Eldorado Canyon Fixed Hardware Application Form

Route Name and Proposed Grade: Brand New Cadillac, 5.11b/c

Location: Cadillac Crag

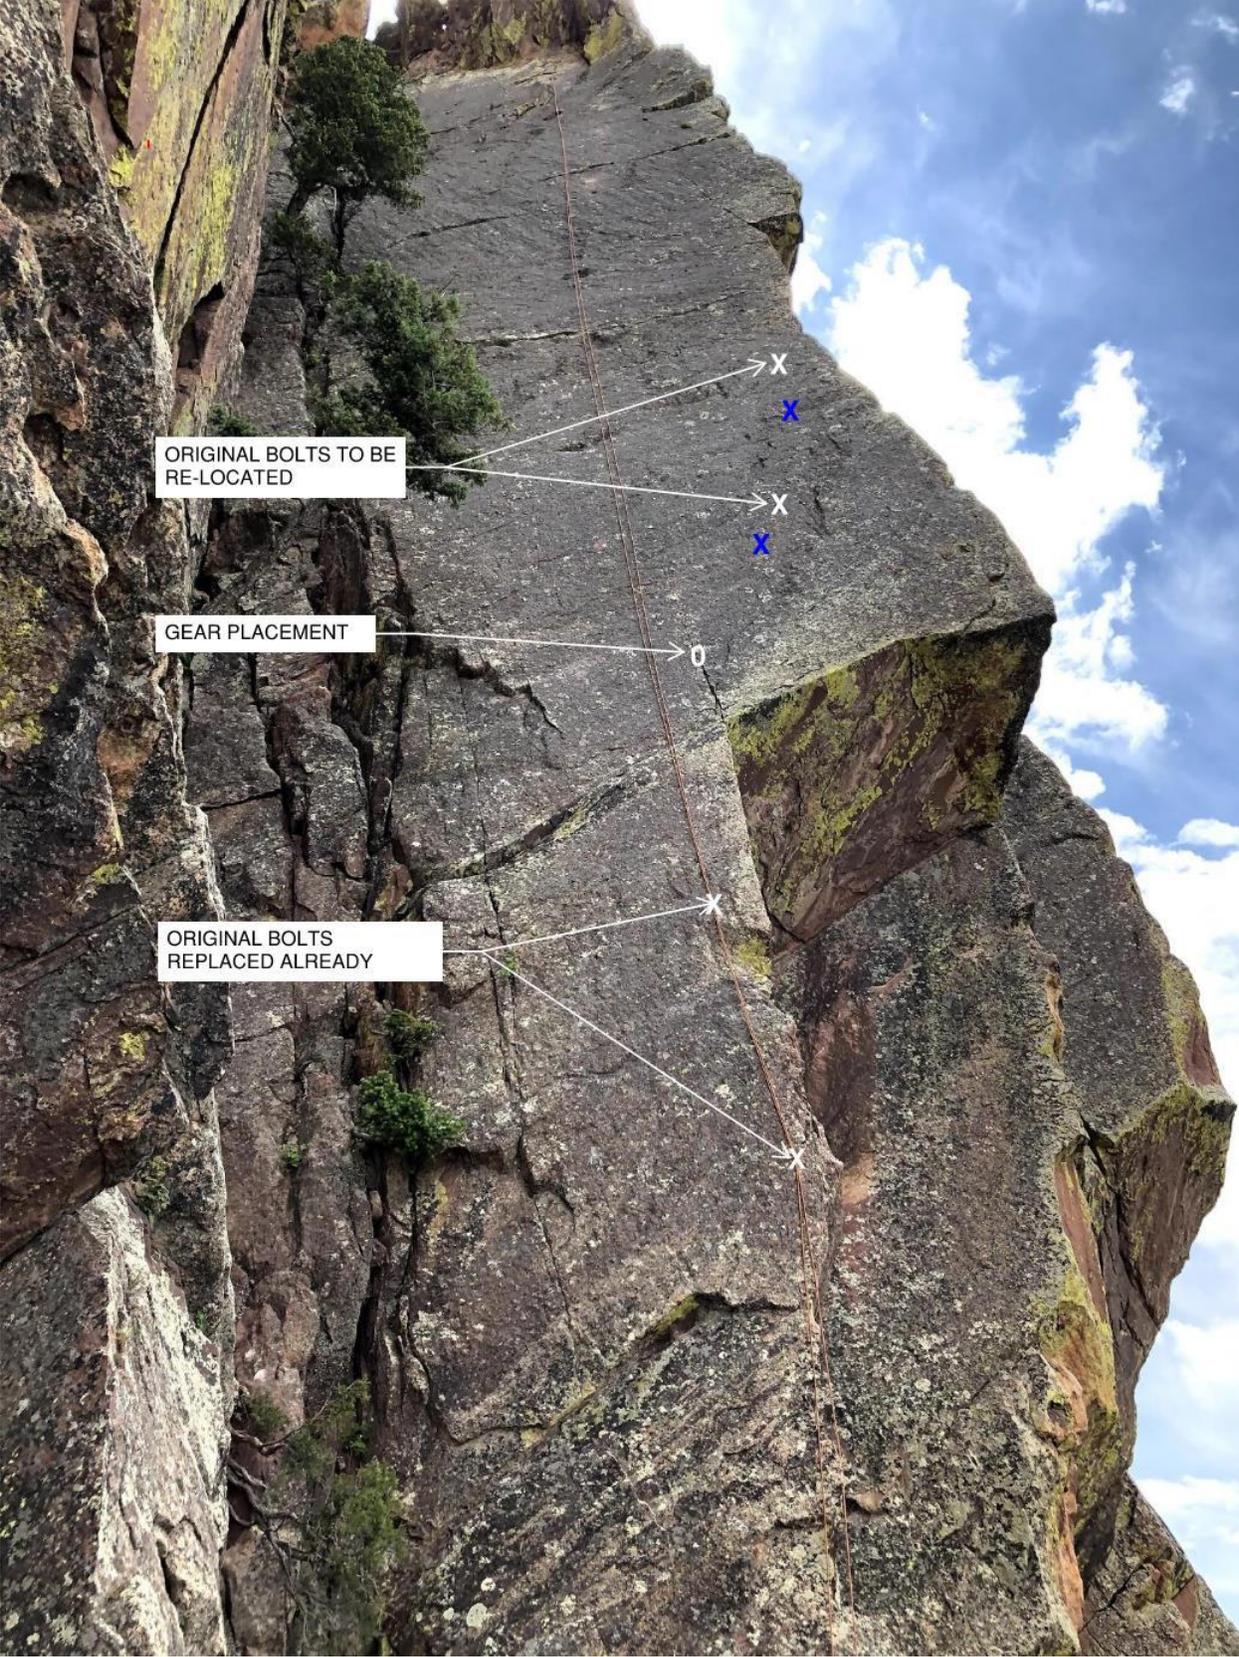
ORIGINAL BOLTS TO BE RE-LOCATED

GEAR PLACEMENT

ORIGINAL BOLTS REPLACED ALREADY

The photo above is of the crux bolt which was placed too high for most people to clip before getting into the moves. A wire draw has been hanging on the bolt for 18 years to make it easier to reach. As part of this proposal we would re-locate this bolt lower.
